# HISTORIC AND DESIGN REVIEW COMMISSION

**HDRC CASE NO:** 2024-338  
**ADDRESS:** 332 FLORIDA ST  
**LEGAL DESCRIPTION:** NCB 3010 BLK 8 LOT 8-9, N 46 FT OF 17 & N IRR 33 FT OF 18  
**ZONING:** RM-4 CD  
**CITY COUNCIL DIST.:** 1  
**DISTRICT:** Lavaca Historic District  
**APPLICANT:** Nathan Manfred/French and Michigan  
**OWNER:** Mae and Frank Miranda/MIRANDA FRANCISCO J & MAE H  
**TYPE OF WORK:** Multiple carport construction and site alterations  
**APPLICATION RECEIVED:** September 21, 2024  
**60-DAY REVIEW:** November 20, 2024  
**CASE MANAGER:** Caitlin Brown-Clancy

332 Florida - Carports and Site Improvements

**5 CASITA CARPORT - SOUTH ELEVATION**  
SCALE: 1/4" = 1'-0"

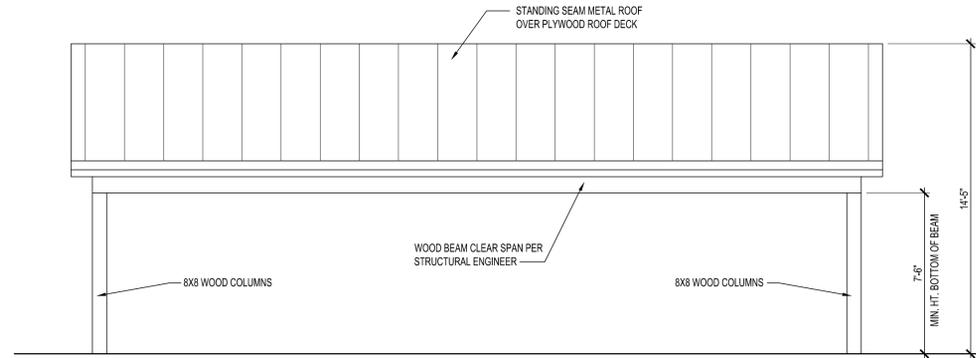
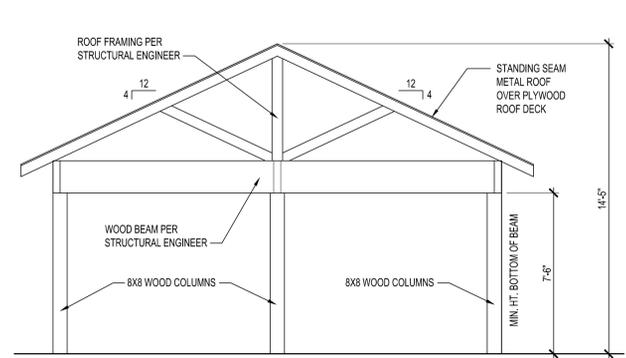
- e. **CARPOR: SCALE & MASS** – The applicant has proposed two carports to include a 1-story detached carport structure with a hipped roof measuring 14’5” in height. The second carport will be attached to the rear of the existing casita with a shed roof measuring 10’0” in height. The Historic Design Guidelines state that new construction should be consistent with the height and overall scale of nearby historic buildings and rear accessory structures. The scale of the proposed structures does not impact or visually compete with the primary structures on the lot or nearby historic structures. Staff finds the proposals consistent with the Guidelines.

- f. **CARPOR: ROOF FORM** – The applicant has proposed a hipped roof form for the detached carport. The roof will be a standing seam metal roof. The applicant has proposed a shed roof for the attached carport featuring a standing seam metal roof. Staff finds both proposals appropriate.

- i. That the applicant submit metal roof specifications to OHP staff prior to issuance of a COA.

**1 PROPOSED SITE PLAN**  
SCALE: 1" = 20'-0"

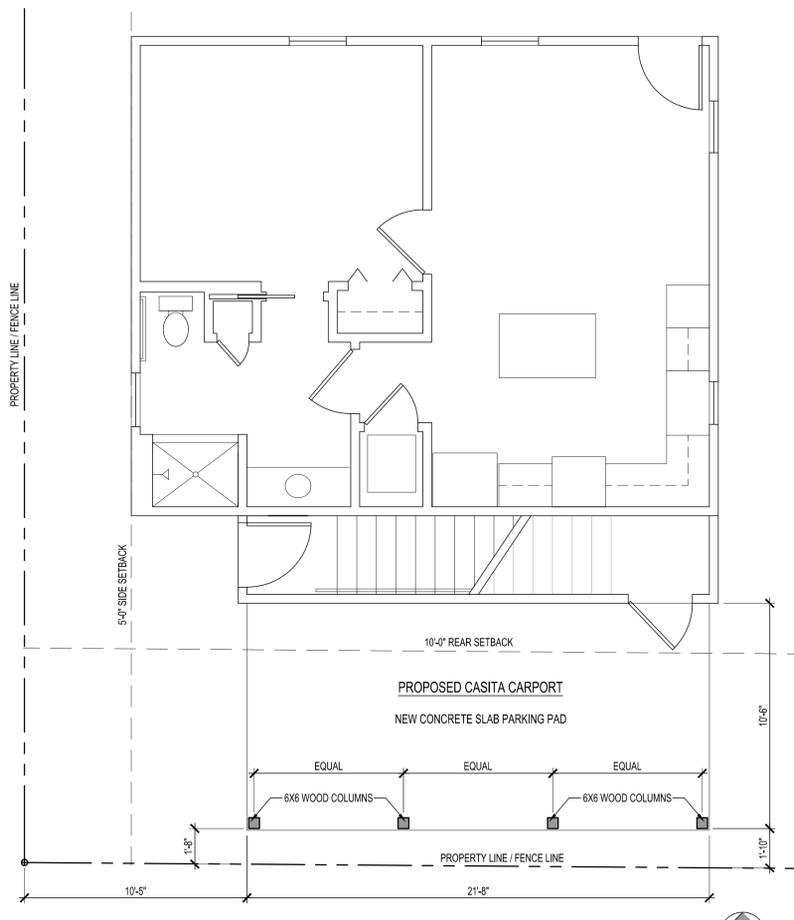
- c. SITE ELEMENTS: NEW DRIVEWAY(S) The applicant is requesting to pour a new 220 sq. foot concrete pad behind the existing casita and a 2,792 sq. foot concrete pad over the existing compacted dirt and gravel drive. With these additions, the lot still features less than 50% impervious cover. Staff finds both requests consistent with the Guidelines.

Staff recommends approval to pour a new 2,792 sq. foot concrete drive based on finding c. However, staff finds a pervious paving system to be most appropriate.
